This Service Information bulletin supersedes SI B65 19 08 **dated October 2008.**

Recall Campaign 08V-384: Modify Seat Occupancy Detection Mat

E83 with base seats

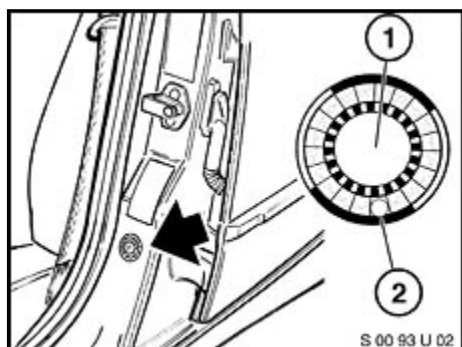
This Recall Campaign has been assigned code number **530**. After the vehicle has been checked and corrected, if necessary, obtain a label (SD 92-352) and:

- A. Emboss your BMW center warranty number in the middle of the label (1);
- B. Punch out code number **530** (2) printed on the label; and
- C. Affix the label to the **B**-pillar as shown.

If the vehicle already has a label from a previous Service Action/Recall Campaign, affix the new label next to the old one. Do not affix one label on top of another one, because a number from an underlying label could appear in the punched-out hole of the new label.
